## ANN ARBOR HISTORIC DISTRICT COMMISSION

### Staff Report

**ADDRESS:** 544 Sixth Street, Application Number HDC11-142

**APPLICATION:** The applicant seeks HDC approval to install a metal chimney for a woodstove behind the ridge of the one-story wing.

544 Sixth Street (May 2008)

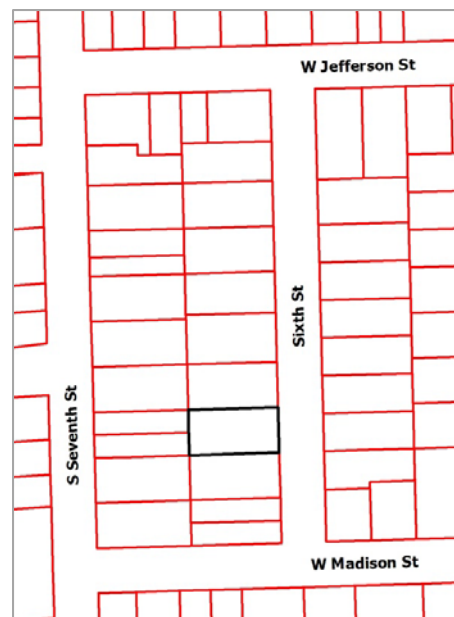
1. The applicant would like to supplement this home's existing radiators with heat from a woodstove. The location chosen is to maximize heat circulation, and on the application the owner indicates that it was also the historic location for a stove.
2. The chimney would extend 3' above the sloped roof and 2' above the ridge, though less would be visible to a person on the street because of the angle. The applicant would paint the chimney matte black upon installation. These details are contained in an email from Evan Hall (the applicant) that is attached to the end of the application form.
3. Staff believes the work is inconspicuous and reversible, and recommends approval of the proposed addition since it meets the *Secretary of the Interior's Standards and Guidelines for New Additions*.

Thanks Evan. I couldn't find the height of the chimney (both total height and visible height from the front would be helpful) on the application; please provide. Also, is the color shown the one you would use? (it's fine, it just needs to be specified on the application or in my staff report.)

The HDC would need to review the application, and they've recently approved two woodstove chimneys. The 2' would be above the ridge, correct (meaning, the chimney above the roof is taller, but 2' is visible)? I think you have a good chance of getting this approved, especially if you use a chimney that's not shiny aluminum – a dull or dark color would be less obtrusive. There's an HDC deadline this Friday for the October 13 meeting if you want to move ahead quickly. I would need an application, a drawing or manufacturer's information on the chimney, and either a drawing or a photo with the chimney superimposed that accurately reflects its size and placement. The application fee is \$100.

The total height is 3' above the roof and 2' above the peak. I show in the photo 2' above the peak, but I assume when standing in front of the house you would actually see less because of the angle. I would have the chimney painted matte black prior to installation.
